E3631A-13C**S E R V I C E N O T E**Supersedes:
E3631A-13B**E3631A DC Power Supply****Serial Numbers: MY51240260 to MY53210014****Metal Strap Kit for tightening loose bumper and for fitting rear lock link in side-by-side rack mounting****Parts Required:**

Figure 1: Top view 3mm gap observed between two different chassis designs

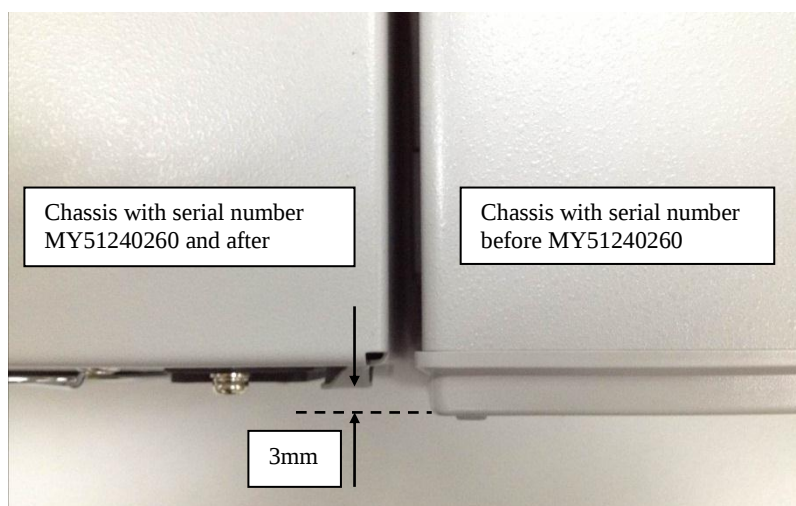
The chassis depth difference between the two designs is 3mm as shown in Table 1 and Figure 1 below.

Serial number range	Chassis depth
MY51240260 and after	345.2 mm
Before MY51240260	348.2 mm

Figure 2: Top view 3mm gap observed on rear lock link for side-by-side rack mounting

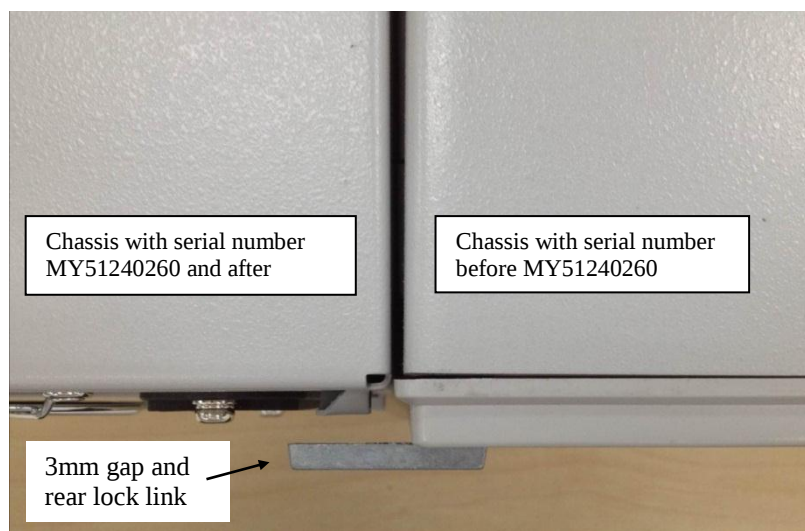
The 3 mm gap between the two different chassis may cause difficulties in securing them together using a rear lock link kit (part number 0050-2167) for side-by-side rack mounting as shown in Figure 2 below.

Use metal strap (part number E3631-07901), and stack the provided two metal straps together to form 3mm thickness and secure it with the provided screws on the rear lock link as shown in Figure 4 below.
